Report No. FAA-RD-71-104

INTERMEDIATE ACTIVITY LEVEL TOWER CAB EVALUATION-PHASE II

| 16. Abstract This project was conducted to determine Air Traffic Controllers acceptance of an intermediate activity level airport traffic control tower, proposed for construction on a national basis, and to obtain suggestions for improving the proposed facility. Full-scale mockups of the tower cab and associated junction room were constructed and equipped with operational equipments at the National Aviation Facilities Experimental Center, Atlantic City, New Jersey. A 2-week evaluation was conducted with participation by air traffic control specialists from each of the 11 Federal Aviation Administration's regions. Results indicate that the proposed tower would be highly acceptable from an operational, as well as an environmental standpoint. Concern was expressed over the large size of the tower cab corner posts and window mullions and over unknown factors relative to the adequate performance of the heating, ventilating, and air conditioning system. Numerous suggestions for both local and national application were determined and documented. | | | |

FIGURE 4 - NAFEC TOWER CAB LABORATORY SHOWING JUNCTION
ROOM LEVEL AND TOWER CAB BASE

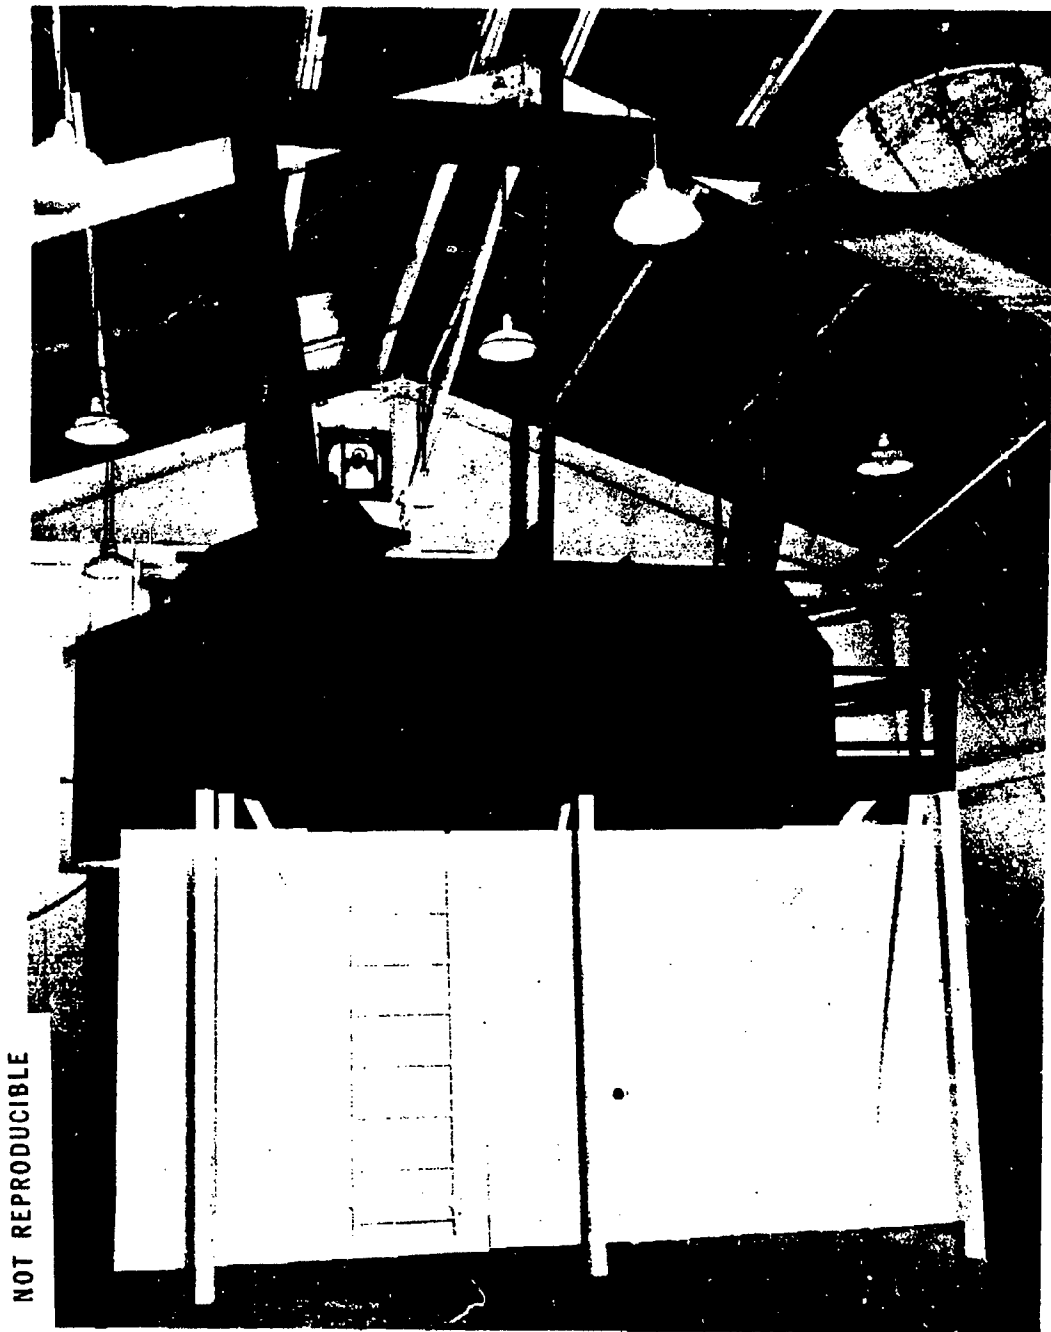
The Junction Room Level: The purpose of the junction room level (Figure 4), in addition to adding height to the tower structure, is to provide an area for a stairway to other levels, elevator shaft or storage room, water pipe chase, lavatory, ac and dc panel boards, equipment racks and clothes rack. The junction room level was rated as follows; stairs from the tower cab to the catwalk landing (Figure 6) and from this landing down to the junction room (Figure 7), very good. The stairs to the lower levels, although not mocked-up, met the standard codes for handrail safety. However, it was suggested that a wire mesh installation be included with the handrail as an added protection feature for facility personnel and visitors.
